City of Toronto – Parks Development & Capital Projects

Kidstown Water Park

Online Survey 3

Summary Report

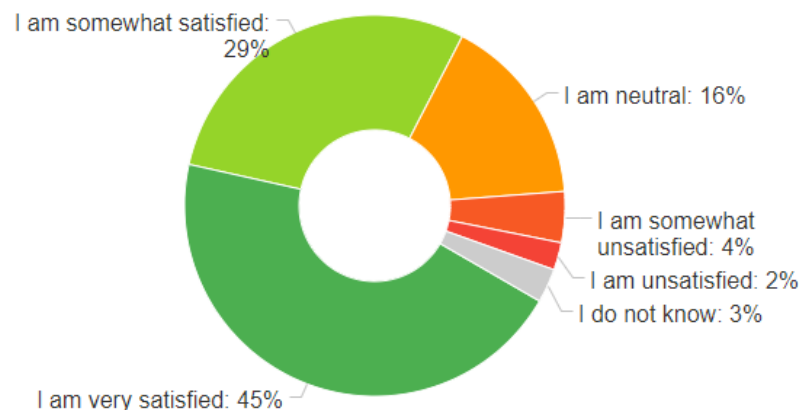
- **Parking Availability**
 - Some participants suggested adding more parking spaces to meet demand. A couple of participants noted that currently, people will use the nearby residential streets for parking.

- A few participants suggested adding more accessible parking spots are required (and in more than one location).
 - A participant suggested:
 - Adding more bike parking.

- Adding designated spots for parents with strollers.
- **Safety and Lighting**
 - A few participants suggested:
 - Adding more stop/"slow down" signs in the parking lot.

- Improving the vehicle entrance/exits including: adding traffic lights; adding a stop sign or middle left turn lane on Birchmount; forbidding left turns into and out of parking lot; multiple vehicle entrance/exit points; and, one way entrance/exit(s).

- A couple of participants suggested:
 - Including cement barriers to prevent vehicles from driving into the park.

- Including only one-way travel in the parking lot (with clear signage).
- A participant suggested:
 - Including an area in the park where young park users can wait and watch the pick-up area, without leaving the safety of the water park.

- Including more speedbumps in the parking lot.
 - Including more lighting.
 - Including a buffer between parking spaces, for wagons, strollers, unloading/loading children, car seats, baggage etc.

- Providing easy access for emergency vehicles.
 - More pedestrian crossings.
 - Including a pathway to the park entrance for pedestrians that does not require walking through the parking lot.

- Ensuring the parking lot is not too close to the entrance.
 - Ensuring plentiful curb cuts from the parking lot to pathways, for those with strollers or mobility devices.

Above: View of the pavilion from inside Kidstown, looking west towards the entrance. The area in the pavilion on the left is for showering with bathing suits on. The colourful changing stall doors are in the center, and the lockers are on the right.

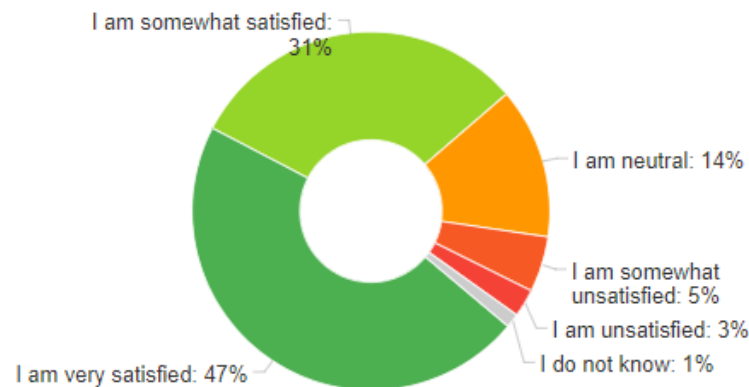
- **Gendered/Gender Neutral Spaces**

- Some participants want gendered washrooms and/or change rooms. A couple of respondents suggested this could be in addition to gender neutral washroom/ change rooms.
 - A couple of participants noted this could be of particular importance to ensure women/girls, and people of Muslim faith, and other religious backgrounds, feel comfortable.
 - A participant suggested an alternative to gendered spaces, that could help people feel more comfortable in gender neutral spaces, could be:
 - A security guard in the gender neutral spaces.
 - Allowing the washroom / change room doors to lock.

- A participant shared that they like that the change area is in the open, so they can be monitored by staff.
 - A participant suggested ensuring all signage for changing and washroom areas are gender neutral.

- **Meeting Demand**
 - A few participants suggested including more washrooms to keep up with demand.
 - A couple of participants suggested including more showers to keep up with demand.

- A participant suggested including more lockers, while another suggested lockers of varying sizes.
- **Accessibility**
 - A few participants suggested providing more large/accessible/family change cubicles.

- Ensure change cubicles are large enough for: families; people with mobility devices; strollers; an adult with stroller and multiple children.
 - *"As a person with a disability who always has to wait for strollers to finish in the larger stalls there need to be 3 to 4 stalls as everyone takes their stroller in when there is space and I have waited for up to a half an hour or more to use a stall in some locations like this."*

- A participant suggested including more family-sized change rooms that fit a stroller and include a shower.
 - A participant suggested:
 - Including change tables in each changing stall.

- Ensuring change tables are accessible for older children with disabilities, and consider a bed lift.
 - Including smaller/lower toilets and step-stools at sinks for smaller children.

- Including a nursing room.
- **Indigenous Placekeeping**
 - A few participants noted that there are opportunities for Indigenous Placekeeping in the design of the pavilion. One suggestion included a domed roof/canopies recalling the shape and designs of the longhouses at the Alexandra Site nearby.

- **Seating**
 - A few participants suggested including more chairs/benches in the pavilion, particularly for:
 - Parents/caregivers to wait for their child(ren).

- Pregnant women and older adults.
 - Near and in the change cubicles, so one child can sit while another is changing.
- **Aesthetic Design**
 - A participant suggested:

- Animal-themed shower heads.
 - More use of colour.
 - A less modern design.
- **Maintenance**

- A couple of participants are concerned about maintenance of the building through the winter.
- A participant suggested minimizing animal nesting/living areas in the pavilion.
- **Other**
 - A participant suggested:
 - Include hairdryers.
 - Ensure the pavilion is well-lit.
 - Include a dedicated, private first-aid space.
 - Add multiple water bottle filler stations.
 - More private showers.
 - More privacy in the pavilion overall.
 - Ensuring the washrooms stay clean.
 - A closed wall to prevent noise from reaching residential areas.

Above: Rendering of the Senior Splash Pad, with Bucket Dump, water room/spray tunnel, and other water play features. The Pavilion, which contains change rooms, washrooms, and offices, is on the right. This view is from the west-central part of the park looking north-west towards the entrance.

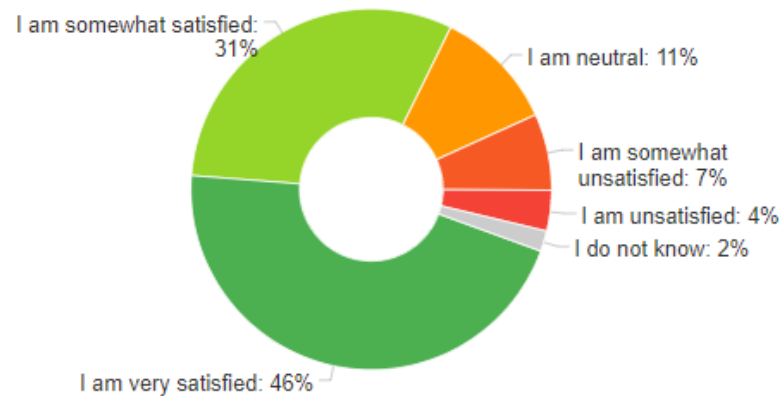
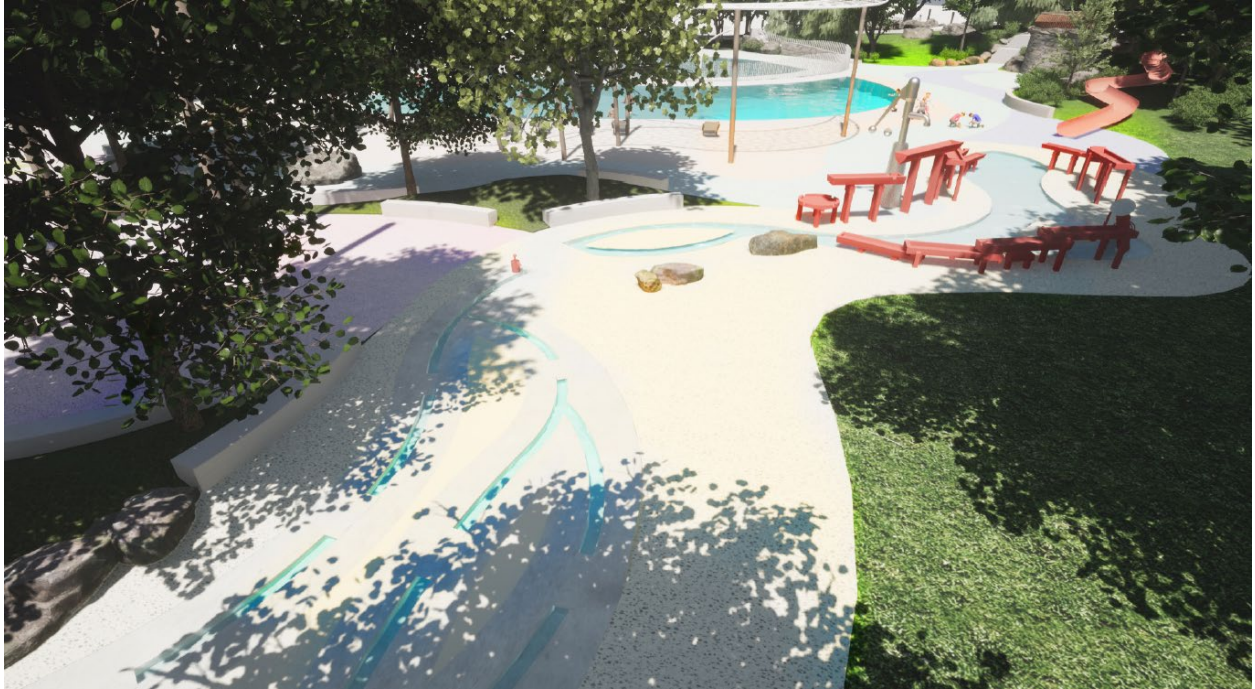
- **Bucket Dump**
 - Many participants shared the sentiment that the bucket dump is currently a defining feature of Kidstown. They feel the proposed bucket dump is underwhelming and needs to reflect the positive parts of the existing design more (e.g. multiple levels, attached features) and include more features (e.g. slides, stairs, sprinklers, more whimsy, more colour).

- A few participants suggested making the bucket dump larger/taller, with a larger floor space to avoid overcrowding.
 - Alternately, a participant suggested the bucket dump be smaller and less intense than the current one in the park.

- **More Colour Features**
 - Some participants feel the design overall is bland and should include more bright, creative, and colourful designs, and more interactive, plentiful, and interesting water play features.

- **Seating**
 - A few participants suggested more seating for parents/caregivers to supervise around the splash pads, including: accessible seating; areas for parents/caregivers to sit with infants; tables and benches; and, both shaded and sunny spots.

- **Safety**
 - A couple of participants:
 - Are concerned about the water shooters, suggesting they either not shoot into areas where younger children are playing, or are not included at all. There is concern these can be used on children who are non-consenting, making an unpleasant space and leading to conflict.

- Are concerned about watching over children when the splash pad areas are divided. A participant suggested ensuring the senior and junior splash pads are easily visible from one another, so that caregivers with one older and one younger child can supervise both of them at the same time.

- A participant suggested:
 - Including a raised edge around the splash pad.

- Including fewer natural elements near the splash pad to prevent dirt and debris entering the space.
 - There is concern that the space between splash pads will get muddy and then slippery.

- Including a stem flow feature similar to Thompson Memorial Park.
 - Ensuring that all in or on-ground water features are large enough to not be tripping hazards.

Above: Rendering of the cognitive play areas, including canals and weirs, water tables and pumps. The view is from the central-southwest of the park looking to the east.

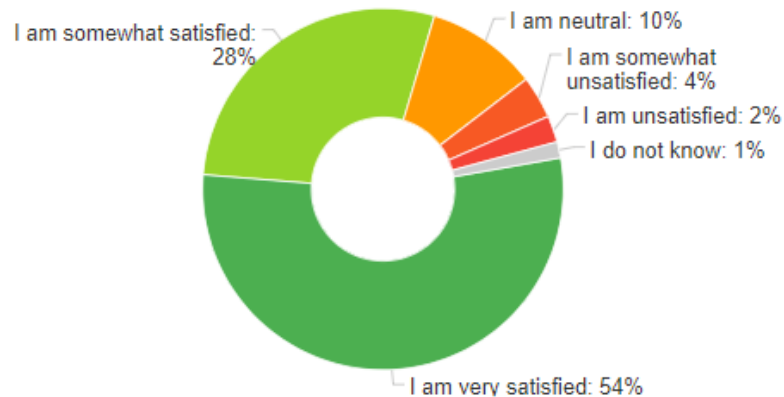
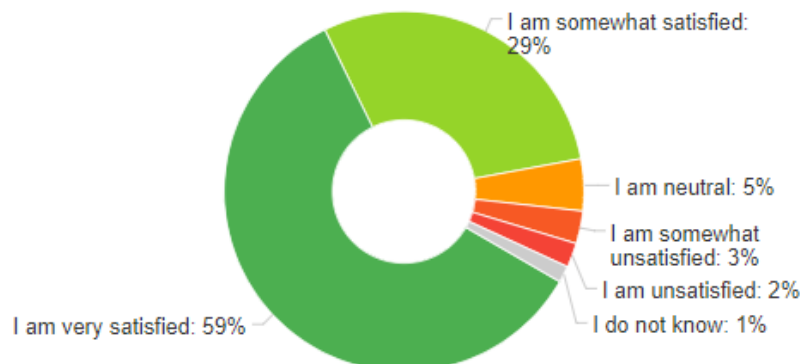
- **Accessibility**
 - A participant suggested:
 - Placing the cognitive play area somewhere more secluded and quite area, as the noise of others playing could be overwhelming for the senses.

- Including (more) sensory toys.
 - A few participants suggested ensuring this area includes features that appeal to older children.
- **Other**
 - A few participants:

- Suggested including more seating in this area, including more shaded seating and more seating for caregivers supervising children.
 - A participant also suggested the seating should not face west, to avoid the afternoon sun.
- Suggested including more shade in this area of the park, while one suggested less.
- Suggested that no sand be used in any cognitive play elements as this would be very messy and difficult for parents/caregivers to deal with.
- Dislike the "forest fountain" feature, suggesting that real wood will rot, be hard to repair, unhygienic, and easily damaged.
 - A couple of participants suggested that the forest fountains were too tall, and should be shorter.

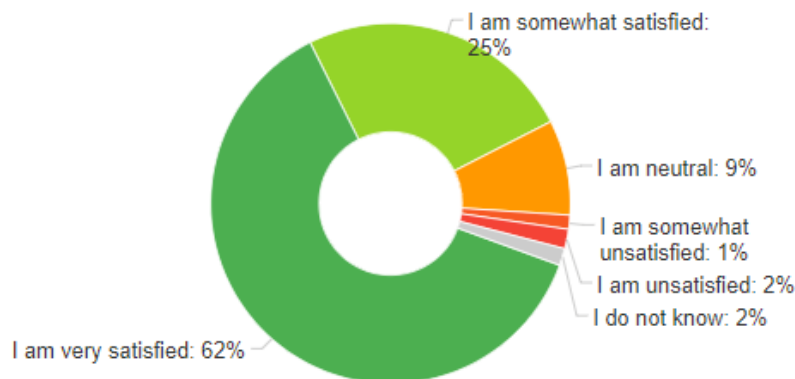
- **Shade**
 - A few participants suggested adding more shade (including through the park, near and over the pools and play areas, and on top of seating areas) and ensuring the proposed shade structure provides more shade than shown in the rendering.

- A couple of participants noted that shade is important for good health and safety in the park.
- **Pool size**
 - A few participants suggested making the pools larger.

- **Seating**
 - A few participants suggested more seating, including near the pools and in shaded areas, so that parent/caregivers can watch swimmers.
- **Slide**

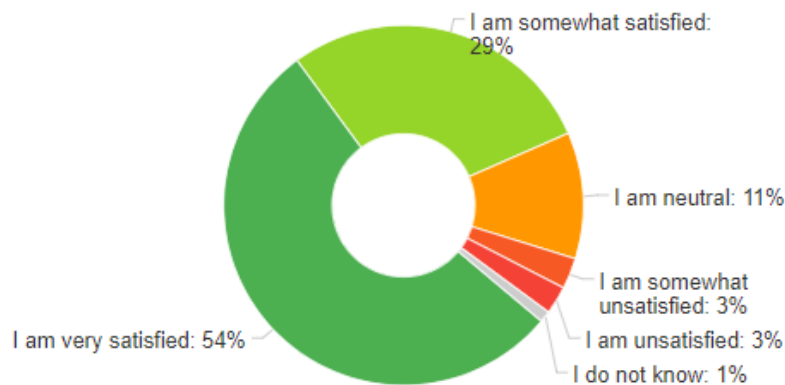
6% of respondents provided written feedback on the design of the waterfall and hill slide area to ensure it is safe, welcoming, and accessible. Key insights include:

- **Slide**
 - A couple of participants suggested including water on the slide.
 - A participant suggested:
 - Ensuring parents/caregivers can either use the slide with their child(ren) or walk along the slide as their child(ren) use it (otherwise they will need to walk all the way around to meet their child(ren) at the bottom of the slide).
 - Including multiple, smaller water slides at this location.

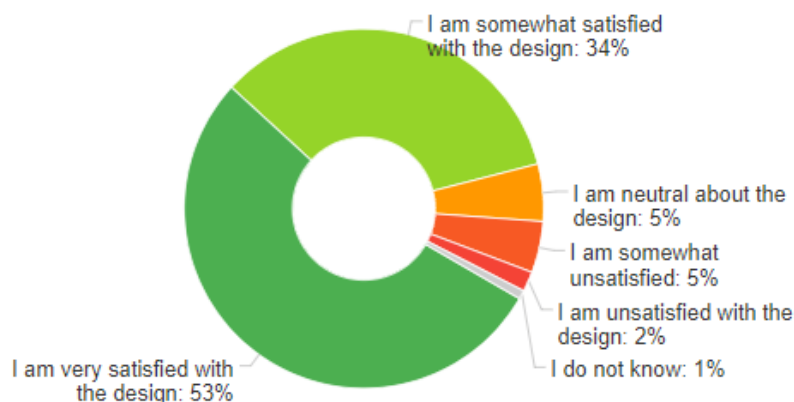
- A couple of participants are concerned:
 - The patio sets look flimsy and might break easily.

- **Paving**

- A few participants were concerned about children slipping and falling on concrete or pavement, with a few participants suggesting alternative flooring like rubber, non-slip, and grass.
- A couple of participants suggested using fun, coloured concrete.
- A participant is concerned that:
 - Rocks in the designs may be pointy and/or slippery when wet, leading to injury.
 - Cafe chairs and tables could be dangerous for families with young children.
 - Exposed aggregate could be rough and uncomfortable to walk on.
